Technical Specification Change Request

Replace page 3/4 7-24 with the attached replacement page 3/4 7-24.

CRYSTAL RIVER UNIT NO. 3

FIG. 1

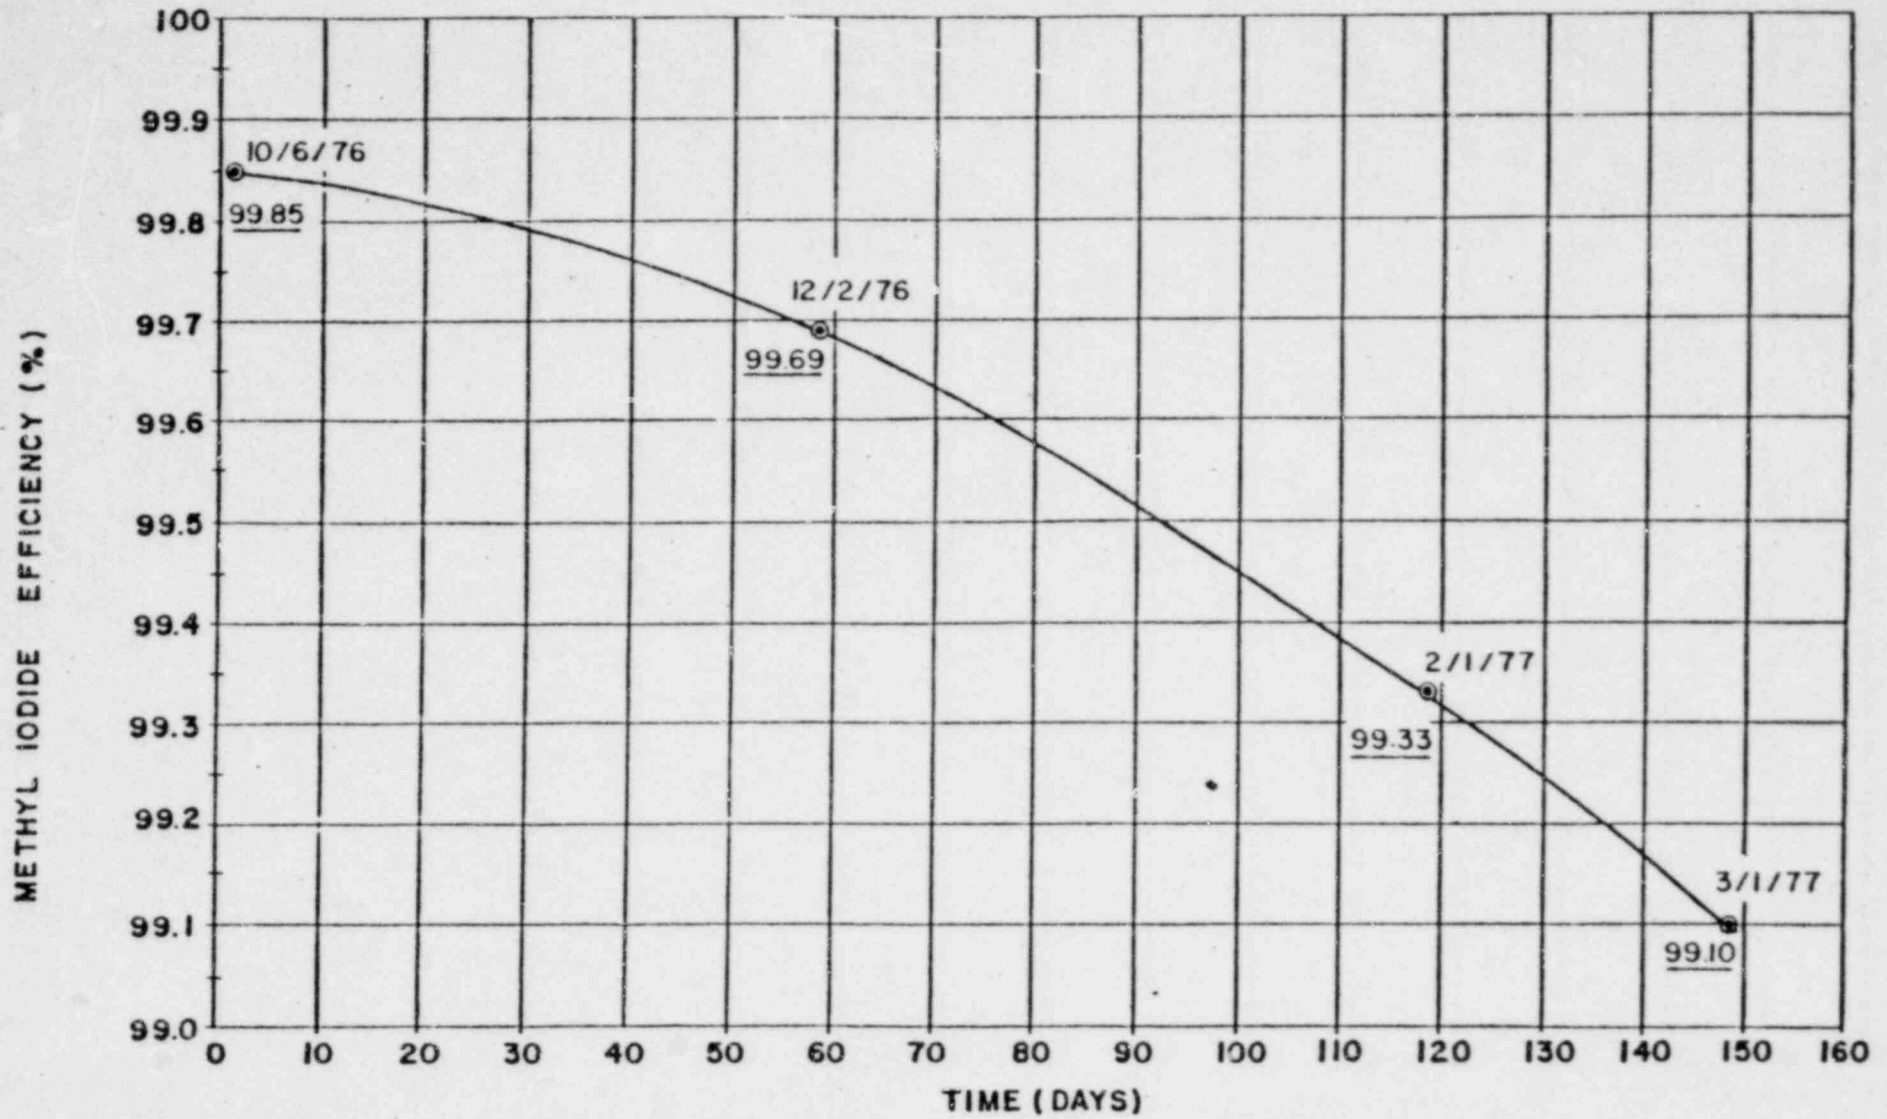
The attached figure shows the results of recent charcoal sample test results. As can be seen, the methyl iodide removal efficiency has dropped from 99.85% to 99.10% in a period of 150 days. The system was operated approximately 120 days during this period. It is anticipated that the efficiency will drop below 99.0% as shown by the next sample test results.
